#### HISTORIC AND DESIGN REVIEW COMMISSION September 06, 2023

HDRC CASE NO:	2023-345
ADDRESS:	216 CAMARGO
LEGAL DESCRIPTION:	NCB 924 BLK 5 LOT 4
ZONING:	RM-4, H
CITY COUNCIL DIST.:	1
DISTRICT:	Lavaca Historic District
APPLICANT:	Henry Tijerina /Tijerina Construction
OWNER:	Ray Langston /LANGSTON RAYMOND & PATRICIA
TYPE OF WORK:	Sidewalk modifications, driveway modifications
<b>APPLICATION RECEIVED:</b>	August 11, 2023
60-DAY REVIEW:	October 10, 2023
CASE MANAGER:	Claudia Espinosa

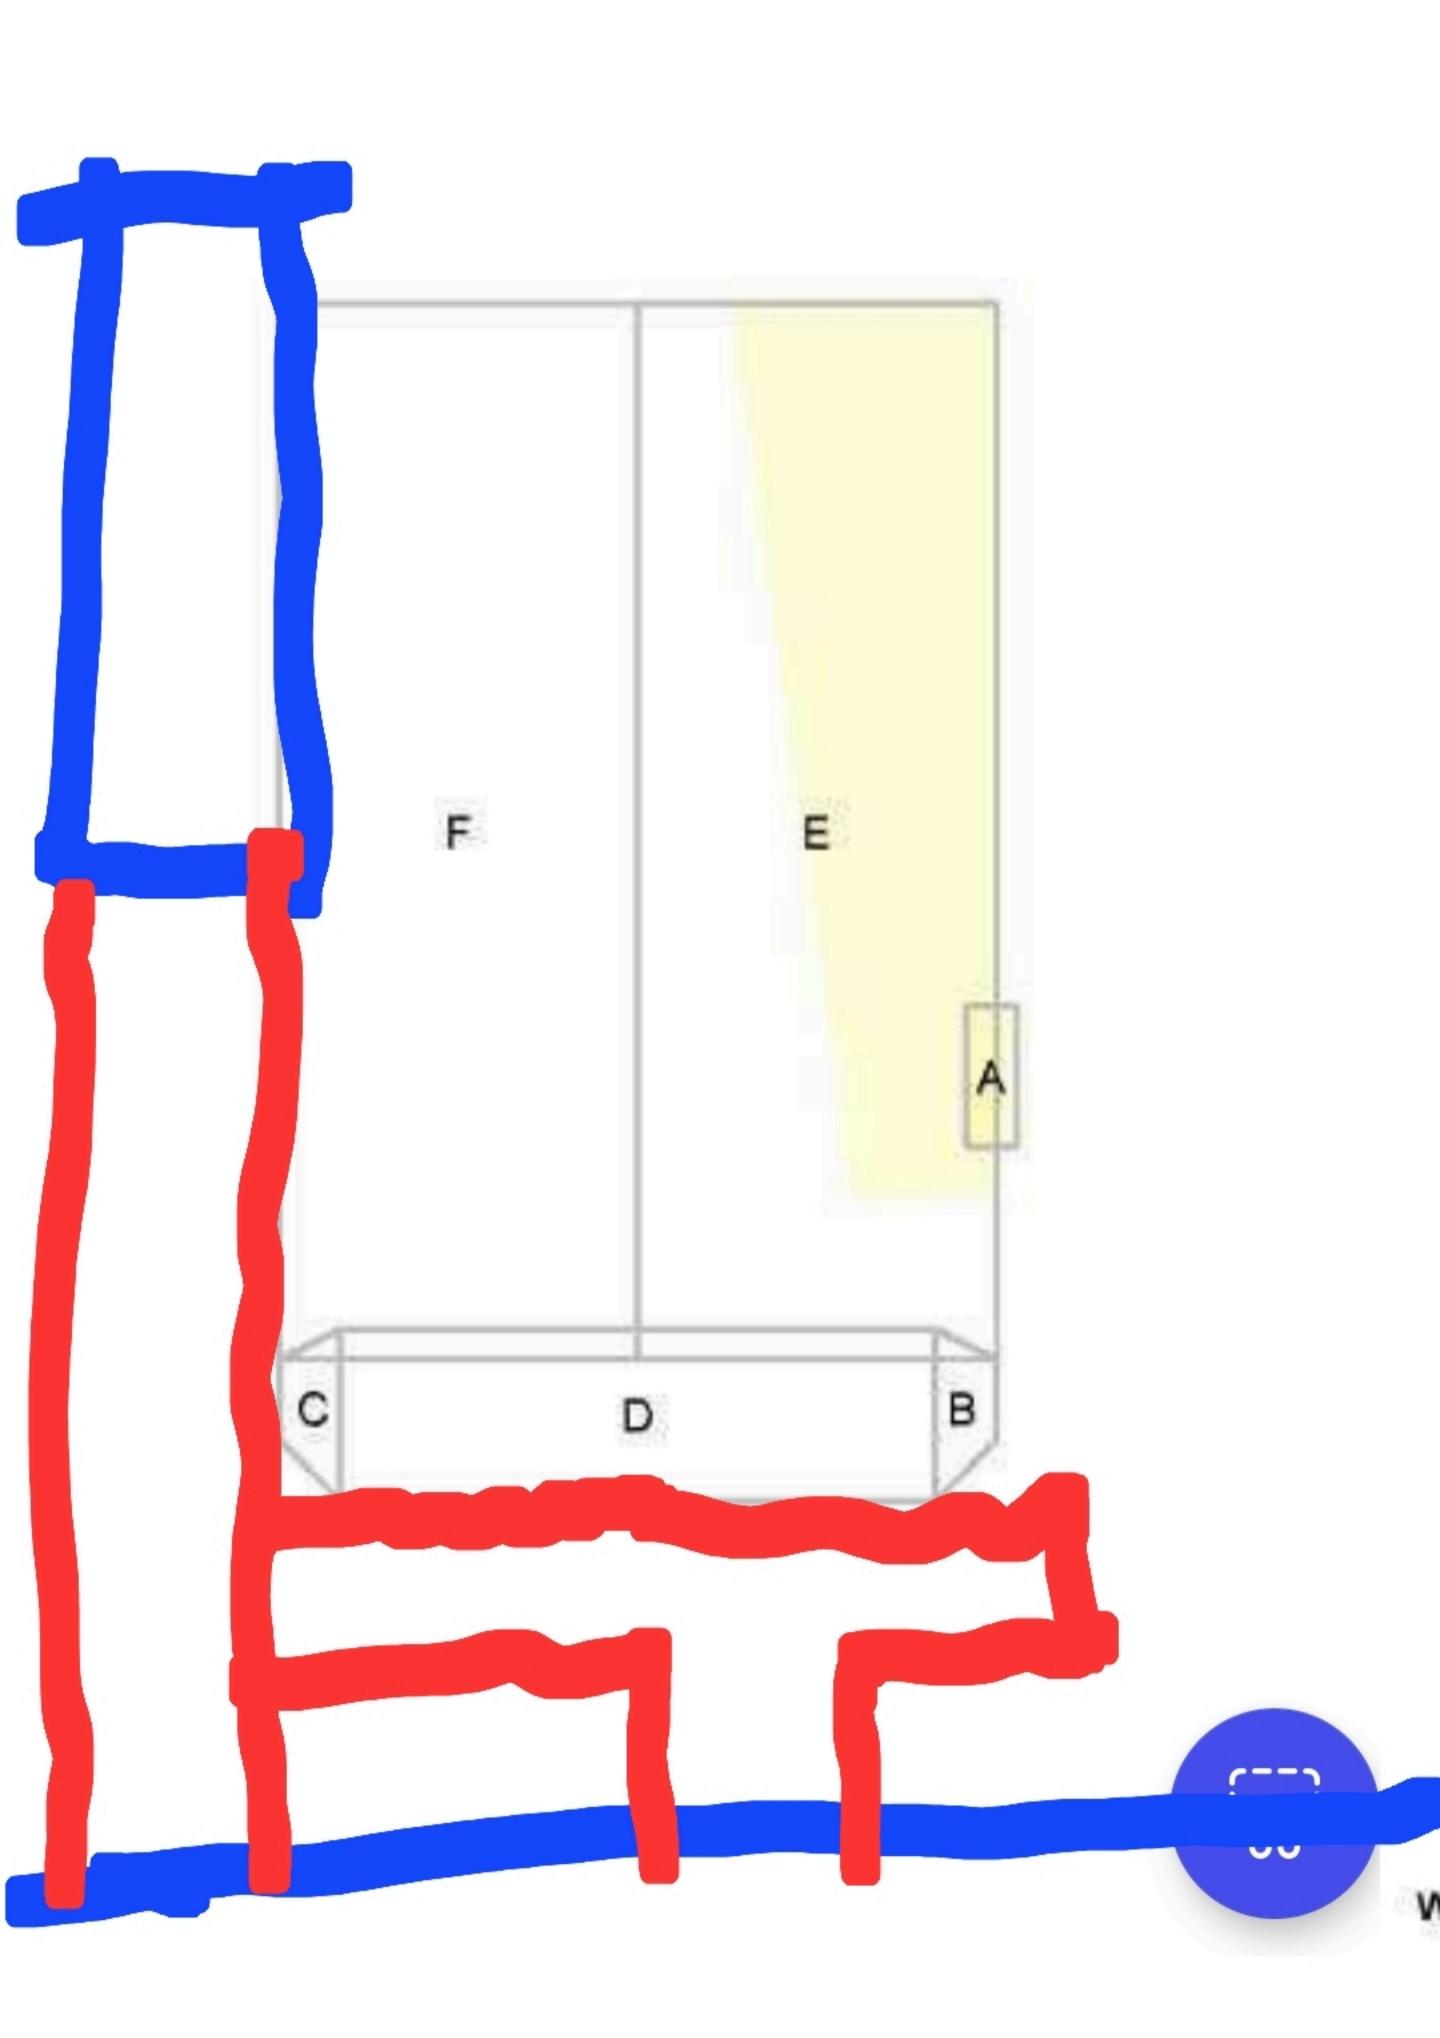
c. SIDEWALK – The applicant is requesting to install new concrete sidewalk connecting the driveway to the existing front walkway and replacing the existing front walkway material with concrete. Per the Guidelines for Site Elements 5.A. ii and iii, portions of sidewalks or walkways that are deteriorated beyond repair should be replaced. Every effort should be made to match existing sidewalk color and material. Follow the historic alignment, configuration, and width of sidewalks and walkways. Staff finds that returning the sidewalk to is original condition and configuration are consistent with the guidelines. Additionally, staff finds the introduction of the walkway connecting the driveway to the sidewalk is generally consistent with the guidelines. Staff finds that the applicant submits an updated annotated site plan to reflect the measurements of the walkway and sidewalk.

Staff recommends approval of item 1, based on finding c, with the stipulation that the applicant submits an updated annotated site plan to reflect the measurements of the walkway and sidewalk.
